Technical Service Bulletin

Transaction No.: **2070110/7**

93 e-tron Mandatory work steps when replacing charging socket UX4/UX5 e-tron - NTC
to PT1000 Charging socket e-tron OBC

Release date: Feb 27, 2026

Figure 1. High-voltage wiring harness for charging socket.

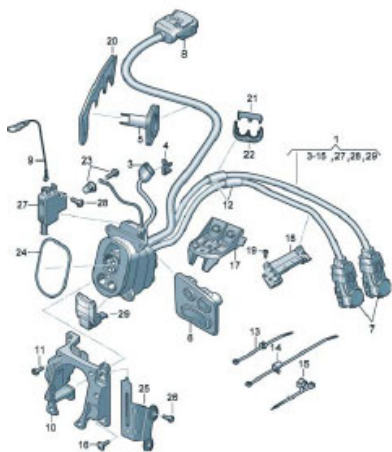
- Please note the following when replacing the high-voltage wiring harness for the charging socket as part of repair work:
- It is essential to check the part number of the removed High-voltage wiring harness and of the new High-voltage wiring harness

The High Voltage Wiring Harness for the charging socket UX4 or UX5 is replaced as part of any repair work (Figure 1).

The charging socket was modified in production.

From June 15, 2020, only the new-generation high-voltage wiring harness for the charging socket is fitted in production vehicles.

It is essential to check the part number of the removed original high-voltage wiring harness and of the new replacement high-voltage wiring harness.

If the high-voltage wiring harness for the charging socket is replaced as listed in Table 1.2, an SVM code will need to be performed, *and a replacement test plan performed.*

If the vehicle in question has the PR number JS1 (second charging socket), both charging sockets must be replaced.
